**SUBJECT:** INFORMATION REPORT  
Application by Lindvest Properties (Cornell) Limited to permit a retail commercial centre at the southeast corner of Highway 7 and Bur Oak Avenue in Cornell Centre.  
File Numbers: OP/ZA/SC 13 126638

**APPENDIX 'A'**  
**Linvest Properties (Cornell) Ltd.**  
**Block 4, 19TM-06012**

**APPENDIX 'B'**

# SITE PLAN

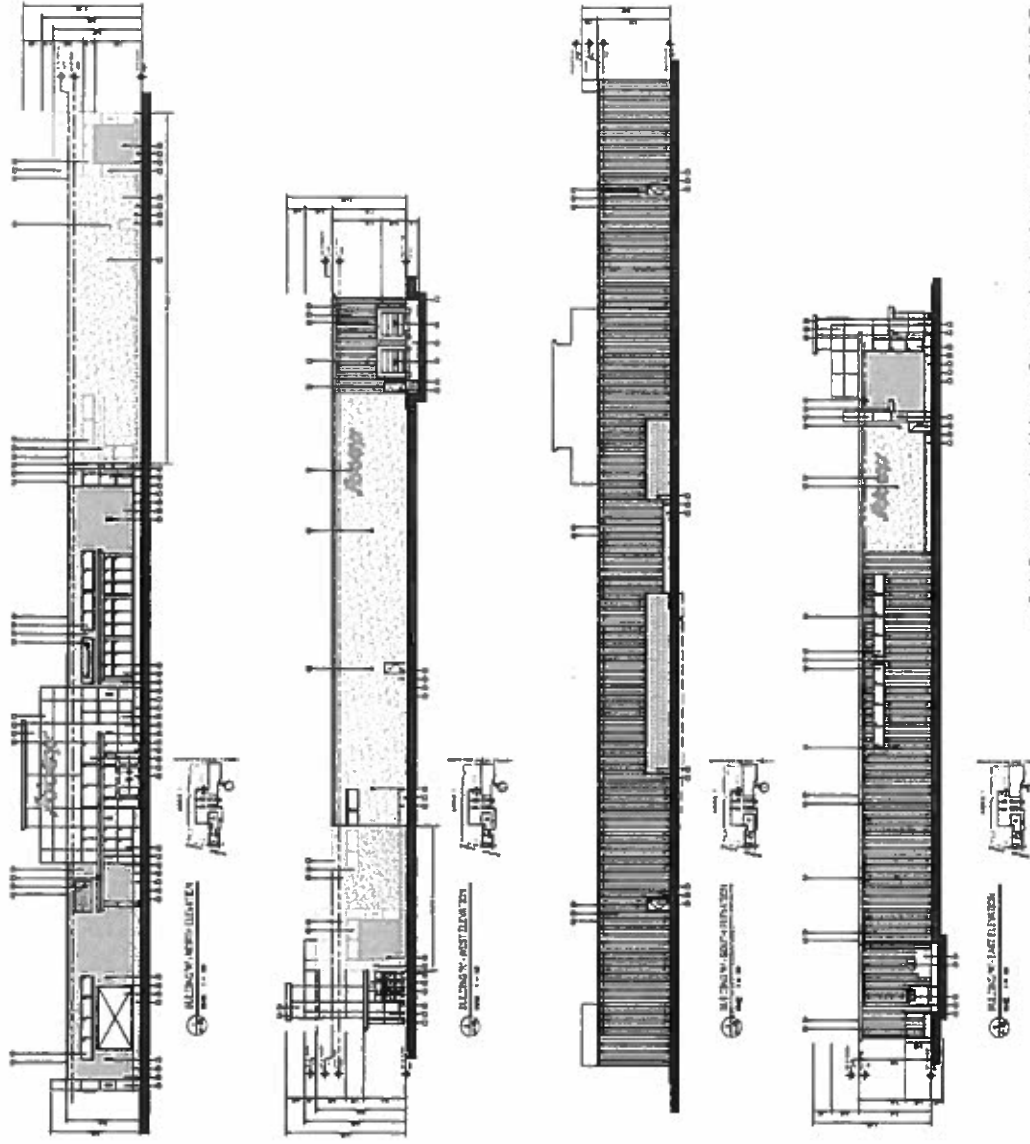
- iv) Demonstrate how in the future the Viva Transit Terminal block will build out if these lands are no longer required by Viva
- c. Create smaller development blocks by introducing a finer public/private street pattern to allow for redevelopment of blocks over time

- d. The number of driveway aisles that intersect with the main east/west private driveway aisle should be reduced to eliminate potential conflicts between drivers, pedestrians and cyclists

- e. Compliance with Region of York Requirements (e.g. proposed zero metre setback proposed for the office building at Highway 7 is not acceptable)
- f. Provide a cross-section through the Highway 7 property line to demonstrate the interface between the buildings and Highway 7 (Highway 7 is not proposed to be urbanized at this time)

- g. Identify areas dedicated for seasonal outdoor retail sales and storage
- h. Demonstrate compliance with parking by-law
- i. Demonstrate compliance with Fire Department requirements

- j. Show turning circles for truck movements particularly in the loading area of the supermarket, to the satisfaction of the Engineering Department
- k. Maximize views and access to the woodlot, respecting natural heritage sensitivities

- p. Noise attenuation measures and buffers related to loading areas (particularly for the supermarket)
- q. Amend property lines to reflect:
  - i) the shift east to the road alignment for the future Bur Oak Avenue to eliminate a proposed retaining wall

# ELEVATIONS

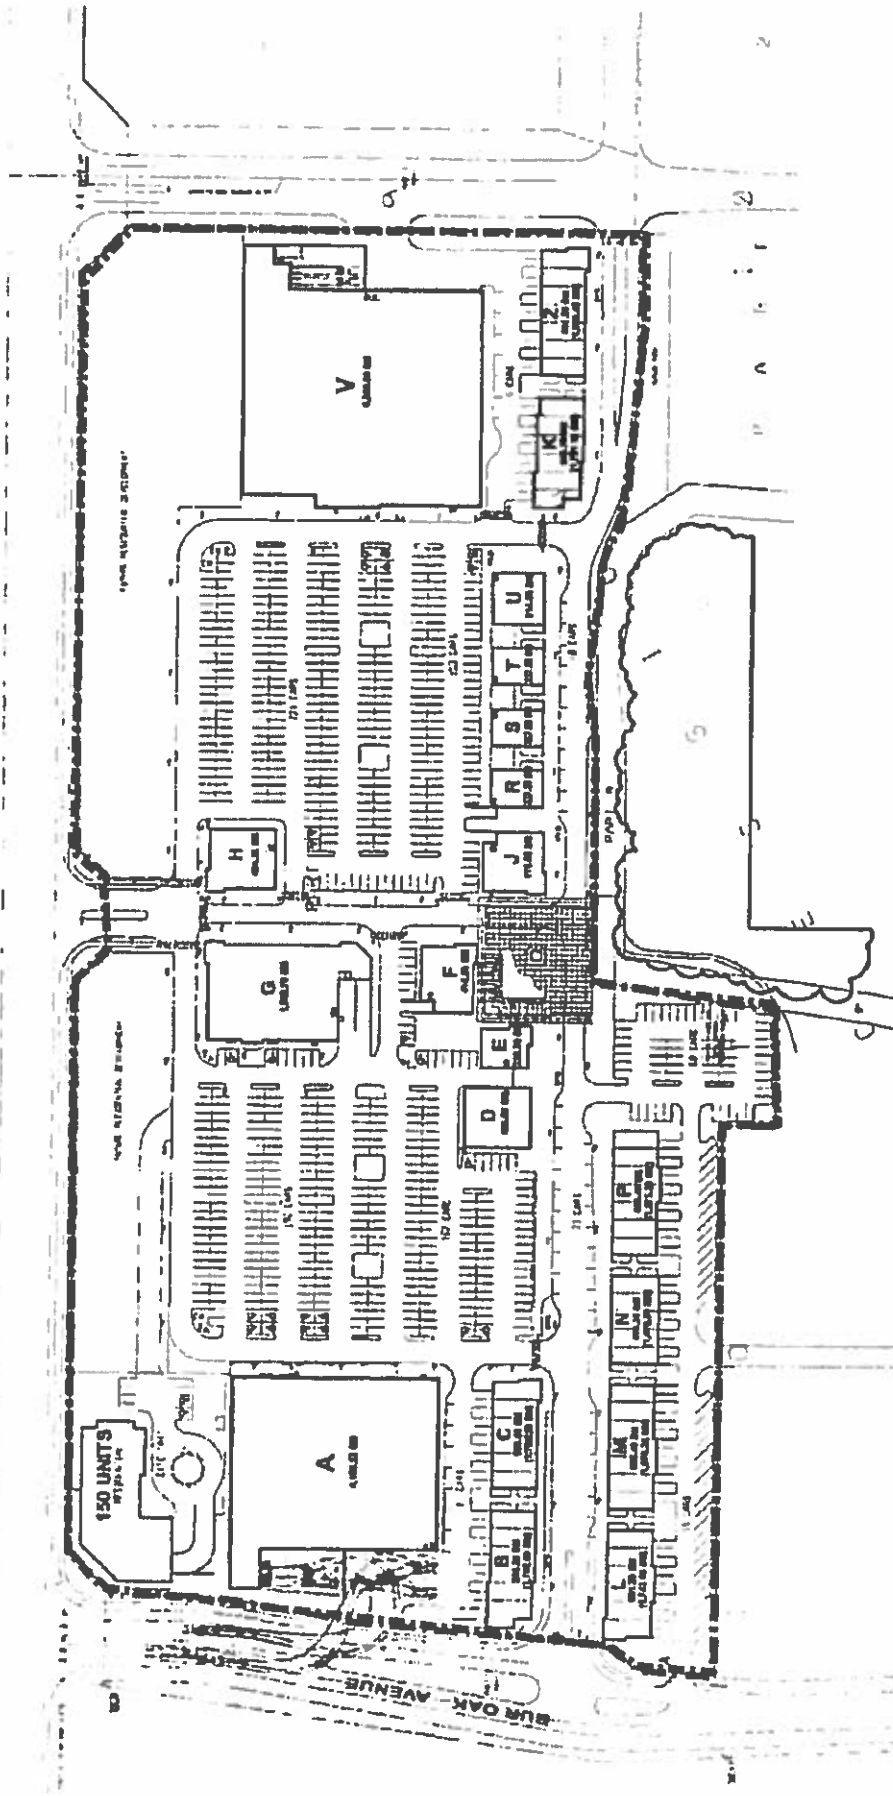
- n. Supermarket should incorporate traditional architectural elements and materials
- o. Proposed supermarket rear elevation, loading and service areas need to be properly screened
